<b>Business Unit:</b>	<b>HARTING Electronics</b>	<b>PCN/21/004/C+N - US</b>
<b>Product Range:</b>	<b>Interface Connectors / M12 PushPull</b>	<b>Date: 2021-02-22</b>
<b>Title:</b>	<b>M12 PushPull Adaptation acc. to IEC 61076-2</b>	<b>Page 1/2</b>

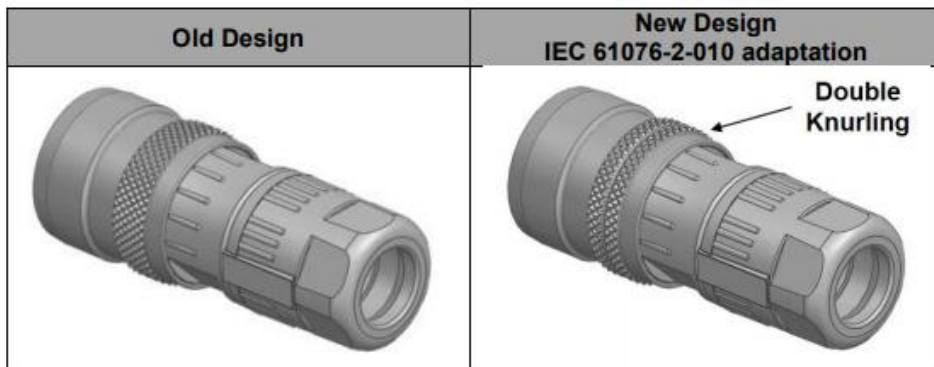
Adaption of products for cable assemblies remains same as announced in PCN/20/027/C+N and will be implemented by modification at existing part numbers. Additionally, and for better visual differentiation a double knurling will be implemented at unlocking ring of modified cable Connectors & Assemblies.

Implementation Scenario IEC 61076-2-010	
Device side	Cable side
Modified version new P/N  <b>PI-NPN</b> + Existing version old P/N 	Modification old P/N  <b>PCN</b>
